# Public Service Commission State of North Dakota

Appendix B

July 23, 2018

The Reclamation Division has reviewed your concerns regarding your land located in the NW $\frac{1}{4}$  of Section 34, T146N, R88W, as outlined in your May 4, 2018 email. Your property is located off-permit and adjacent to Surface Coal Mining Permit NACT-9501 at the Coteau Properties Freedom Mine.

PostMine Topography, Landuse and Imagery above NW1/4 34, T146N, R88W

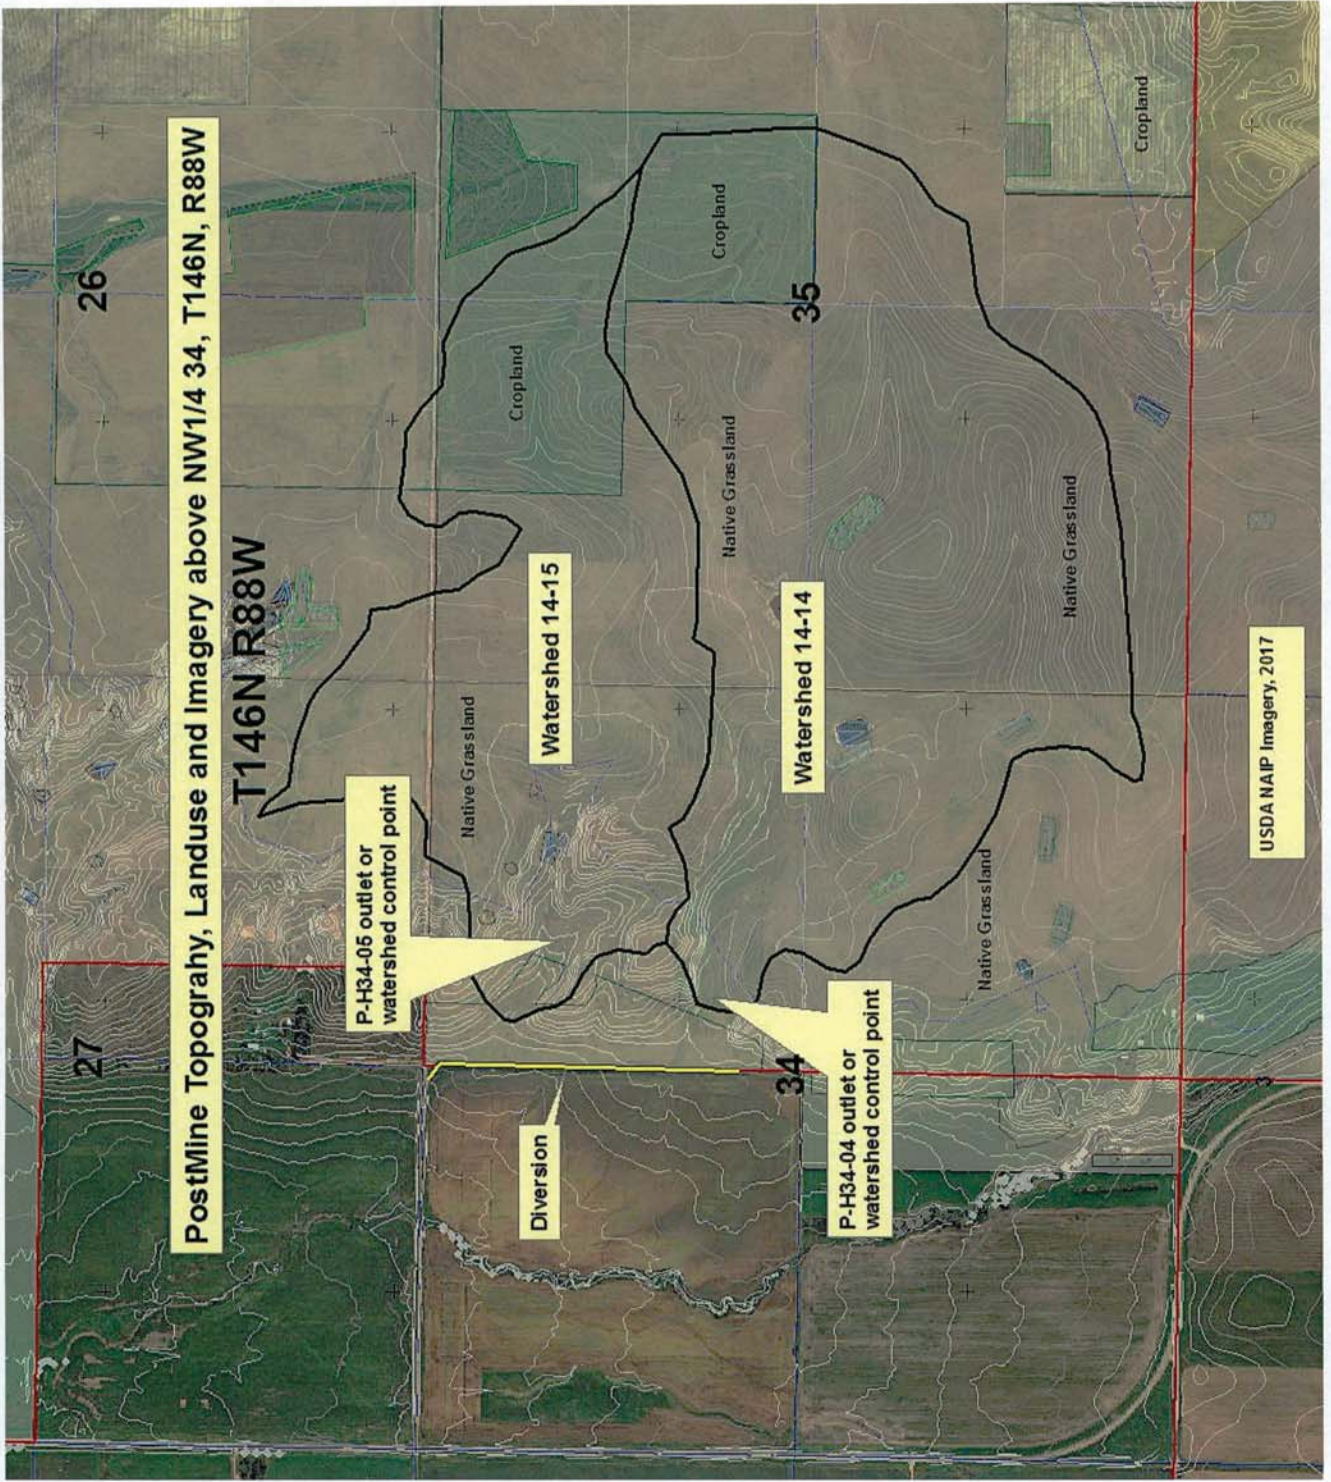
On August 28, 2007, Coteau submitted the application for Revision No. 30 to Surface Coal Mining Permit NACT-9501. This revision proposed changes to the postmine topography and watershed boundaries in the NE¼ of Section 34. The size of watershed 14-14 (most of the area controlled by sediment pond P-H34-04) decreased slightly (5 acres smaller than premine) but the size of watershed 14-15 (most of the area controlled by sediment pond P-H34-05) was increased by 132 acres. The combined area of watersheds (14-4 and 14-15) increased by a total of 127 acres. Revision No. 30 also proposed some land use changes for the NE¼ of Section 34 including changing the postmine land use of a portion of the watersheds from cropland to native grassland. Attached are maps depicting pre- and post-mine watersheds 14-14 and 14-15.

Our analysis shows that even though the total combined watershed size increased after reclamation, the expected total flow rates and volumes are less than the premine condition. This is due to a number of reasons but is primarily due to the reclaimed or postmine watersheds being less steep than the premine watersheds. The premine average slope of watershed 14-15 was 12.7% and the postmine average slope is 4.4%. In addition, the shallow and claypan soils that were common in the premine watershed were replaced with deeper, loamy soils with higher infiltration rates. In addition, there is less cropland and more native grassland in the reclaimed watershed than in the premine watershed. The perennial native grassland vegetation generally has a lower runoff potential than cropland.

**Required Action:** During our reanalysis of the Probable Hydrologic Consequences (PHC), we noted the reclaimed grassland drainage channel for watershed 14-15 (within the permit area) enters the reconstructed diversion at a right angle and drops several feet in elevation over a very short distance. This configuration has resulted in erosion and maintenance problems in the past. The original drainage channel flowed in a more northwesterly direction and entered the existing diversion near the northeast corner of the NW¼ of Section 34. We will require Coteau to re-route this drainage channel in a more northwesterly manner, similar to how it existed prior to mining. This will result in a more stable configuration and much of the drainage from watershed 14-15 will flow almost directly into the east-west reconstructed road ditch rather than flowing into the north-south reconstructed diversion. As a result of this reconfiguration, most of the drainage from watershed 14-15 will "bypass" your property with the exception of the south road ditch. Most of this "reconfiguration work" will take place within the permit area; however, the point at which the reconfigured drainage channel will enter the reconstructed diversion is located on your property and we encourage you to work with Coteau to accommodate the reconfiguration of this drainage channel.

Project: Eisenbeis PostMine2    Simulation Run: Run 10-24  
 Start of Run: 26Jun2018, 08:00    Basin Model: Basin 14-15  
 End of Run: 27Jun2018, 08:00    Meteorologic Model: 10yr/24hour  
 Compute Time: 23Jul2018, 09:23:35    Control Specifications: Control 10\_24

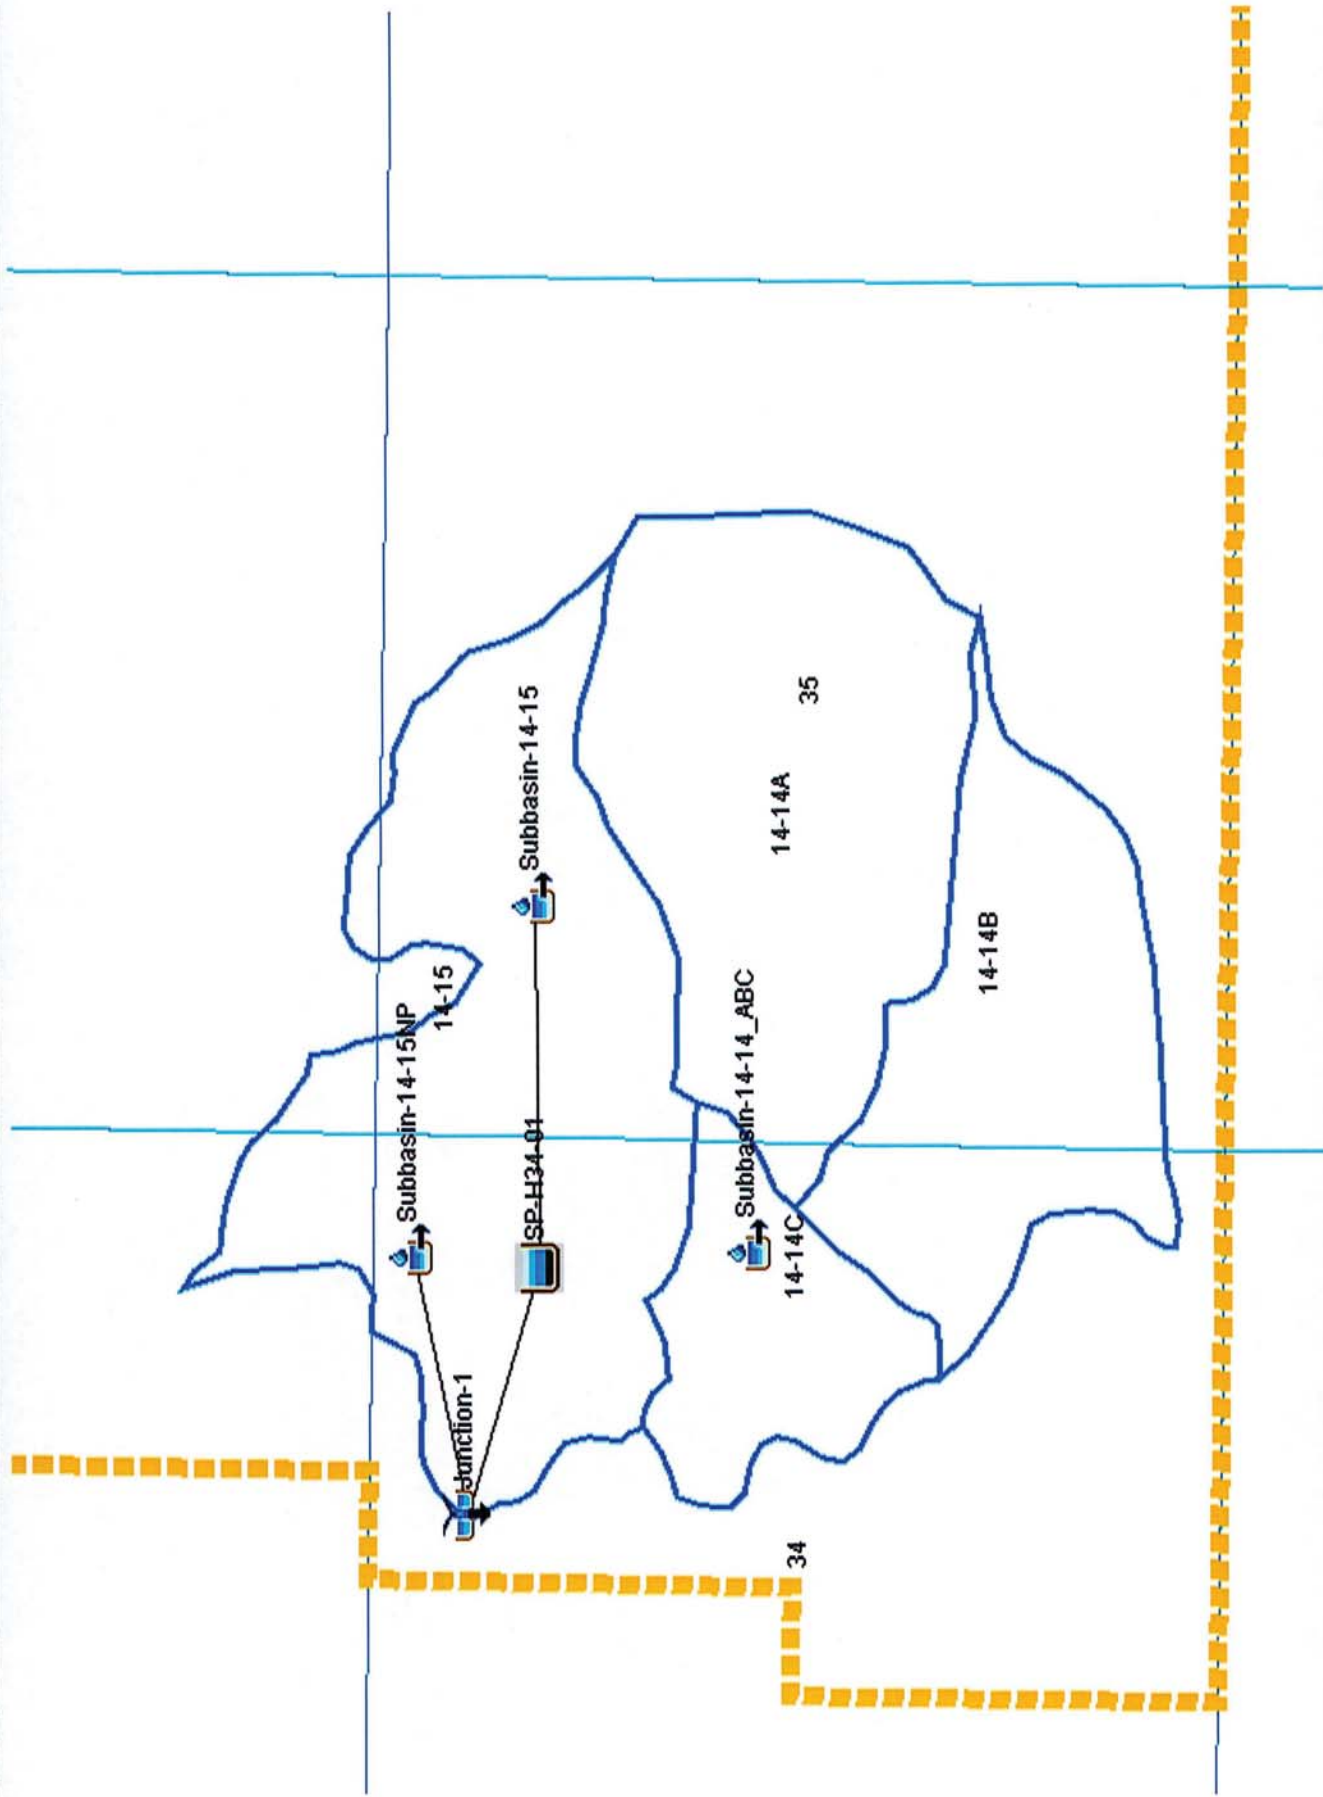
The Reclamation Division staff have reviewed the flow modeling provided by Coteau and have determined the parameters and assumptions used were appropriate and reflected the actual conditions. In response to your concerns, staff again modeled both watersheds and the results of our independent modeling are similar to those provided by Coteau in Revision 30. A copy of our analysis is attached.
